October 16, 1998
W.O.#5244

SUBJECT: **CONDITIONAL LETTER OF MAP REVISION BASED ON
PHYSICAL CHANGES FOR THE EAST C-1 DETENTION
BASIN**

IN REPLY REFER TO:
Case No.: 99-09-066R
Community: City of Henderson, Nevada
Community No.: 320005

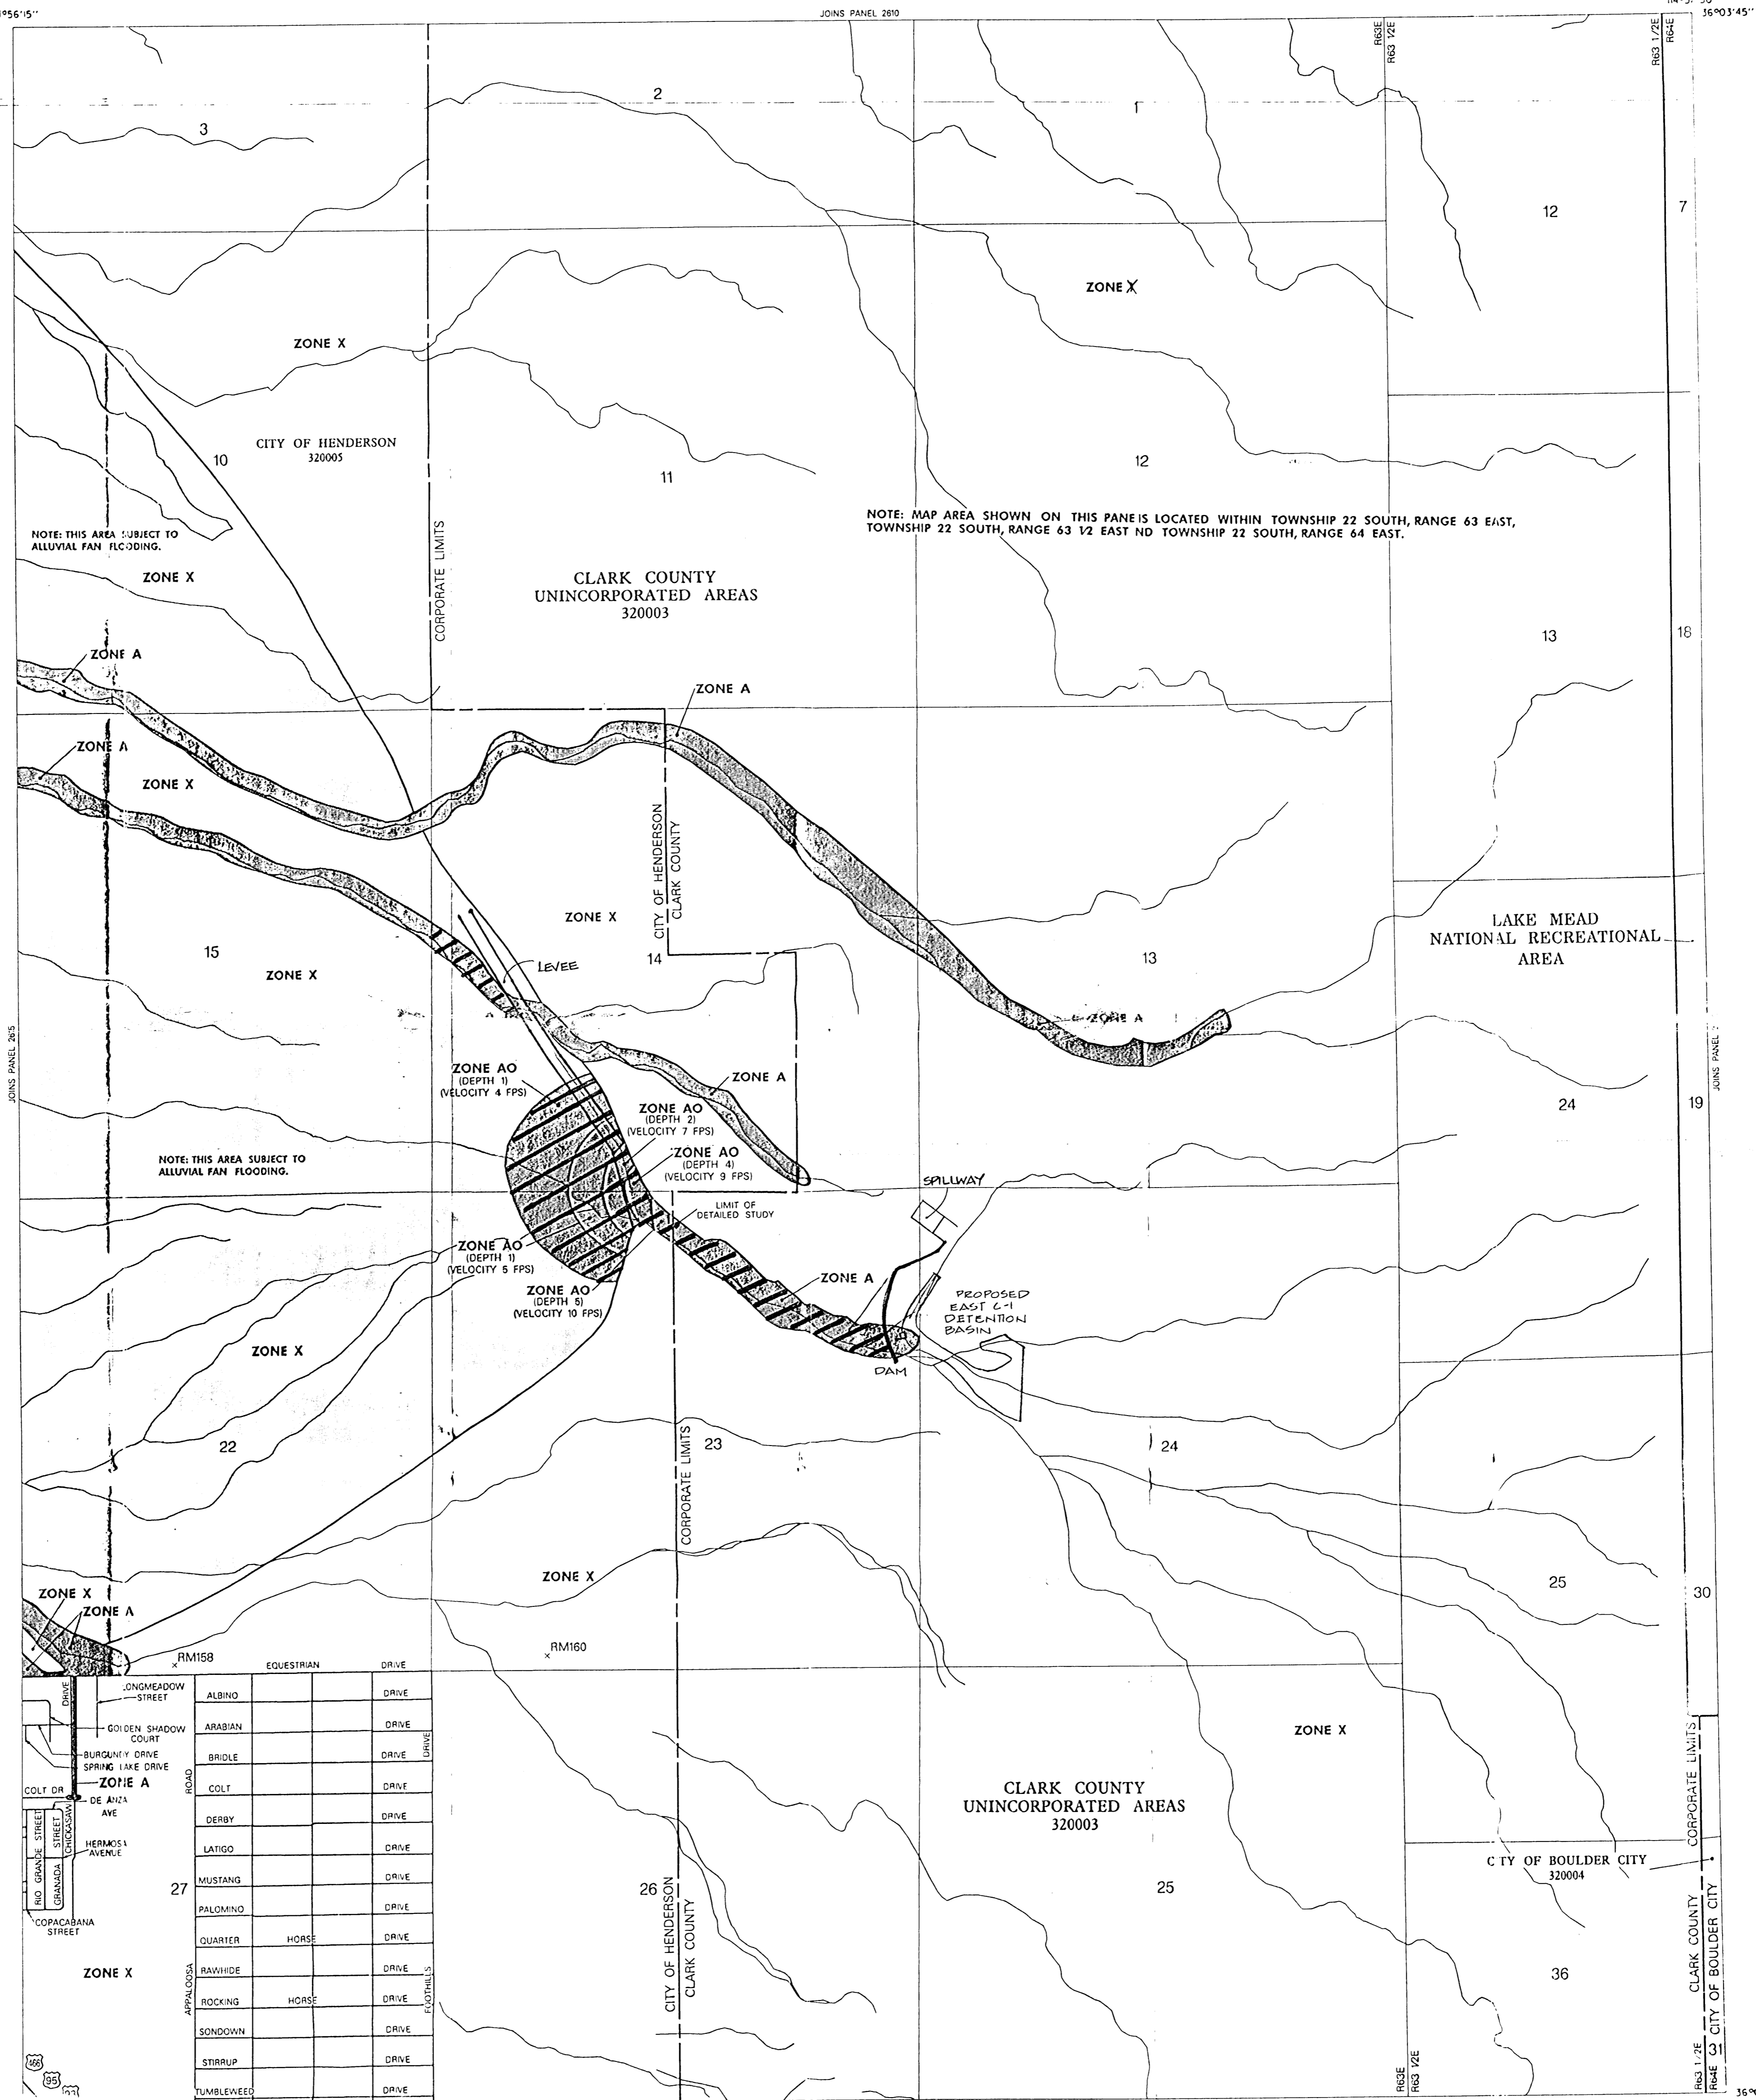
An annotated FIRM for the East C-1 Detention Basin CLOMR showing the proposed revisions has been included with this request, demonstrating that the Zone A floodplain should no longer exist Northwest of the East C-1 Detention Basin and Levee.

HATCHED AREAS INDICATE PORTIONS OF ZONE "A" TO BE ELIMINATED.
